SERVICE PARTS LIST FOR MITSUBISHI ELECTRIC PACKAGED AIR-CONDITIONERS

Series : PEFY-P•VMHS-E-F

REVISED

BWE01805C

EXTERNAL PARTS (2)

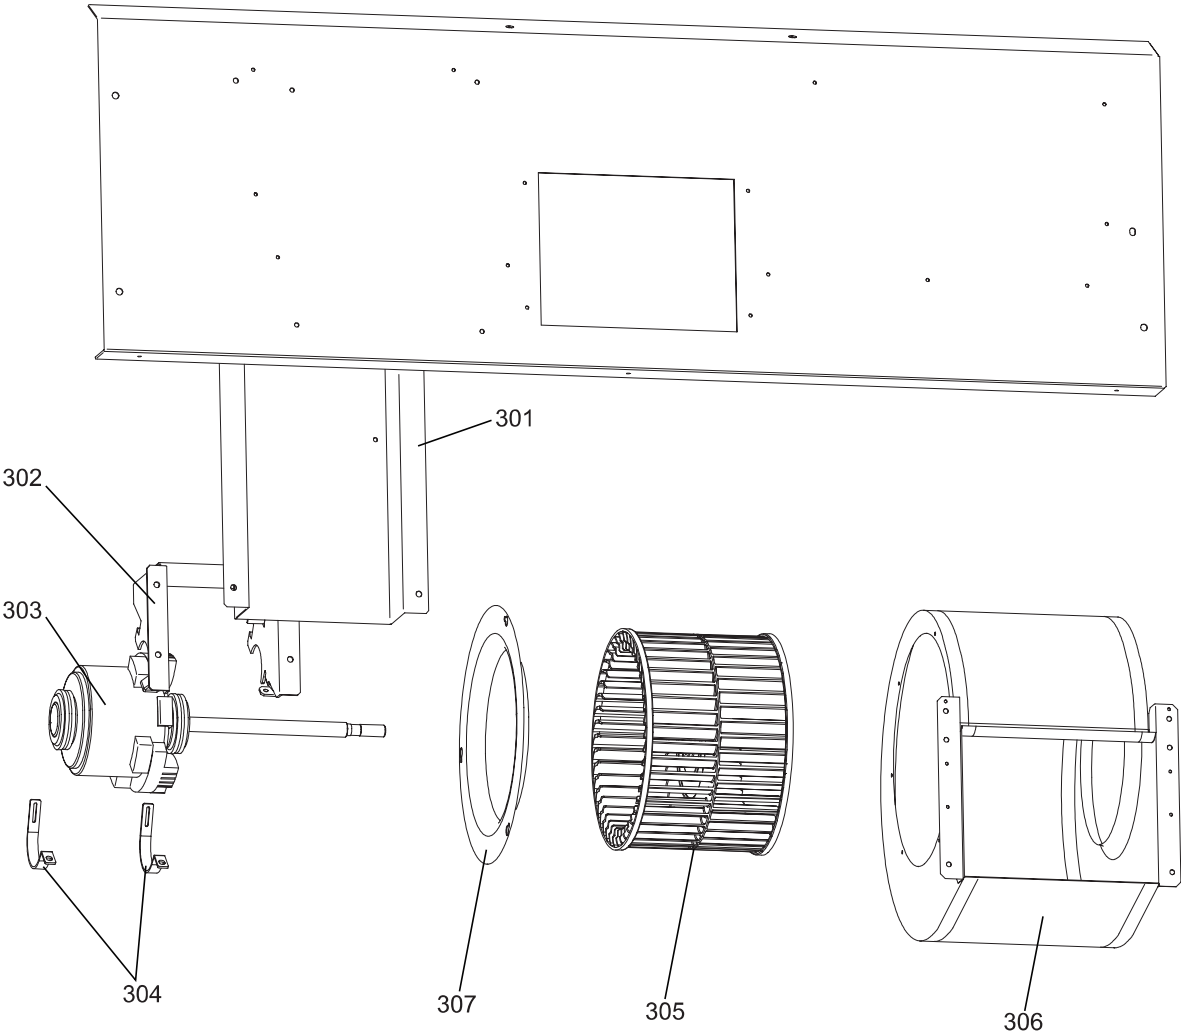
*1 Products manufactured to Sep. 2019 use EFM type LEV,
and products after Oct. 2019 use PAM type LEV.
In case of EFM type LEV is used, please change to PAM type LEV.
In that case, replace it with a set of 103 and 116.
Please order 117 when replacing only the motor part with EFM type.

BLOWER PARTS (2)

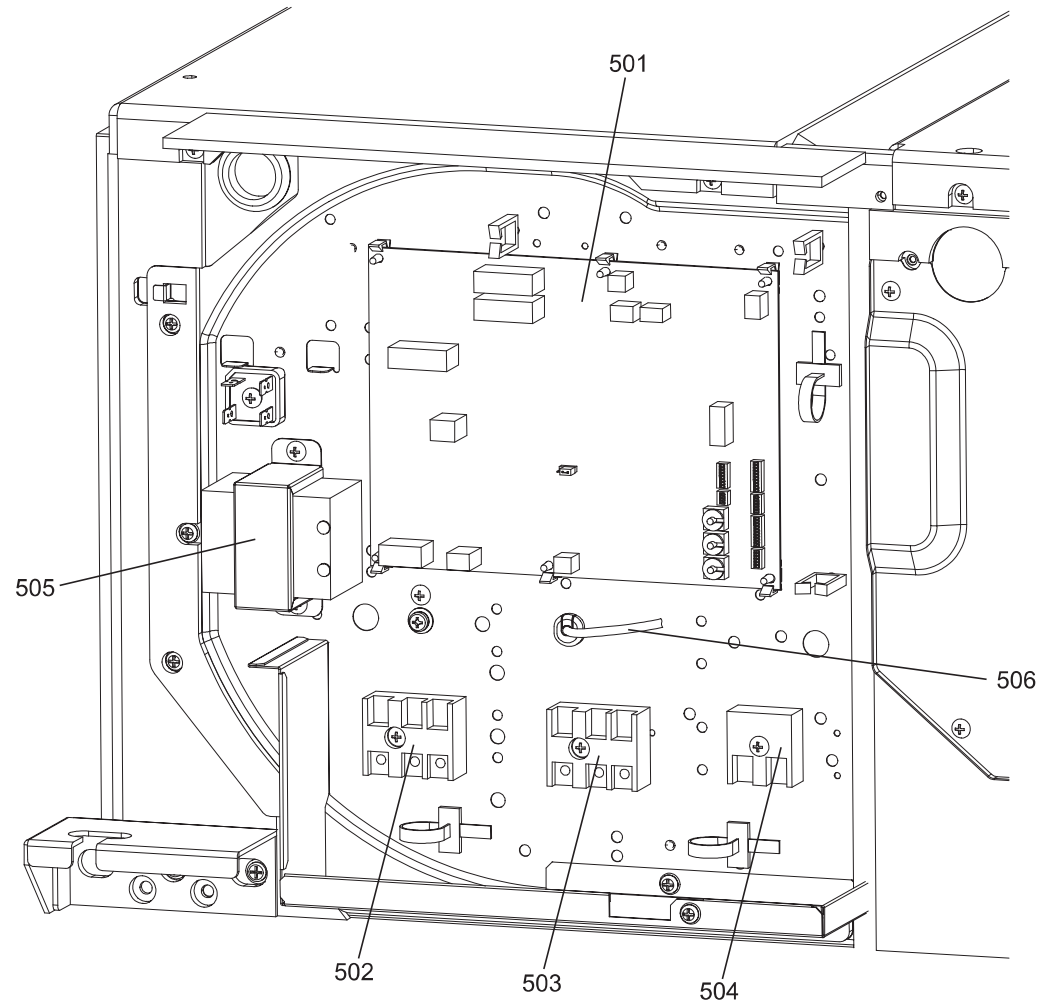
*2 Units with the serial numbers 9YW***** or earlier do not have the grounding wire.
When replacing the motor on the unit that has no grounding wire, prepare 409, not 403.
To check whether the unit has the grounding wire or not, see the part indicated as "MF" on the wiring diagram plate.
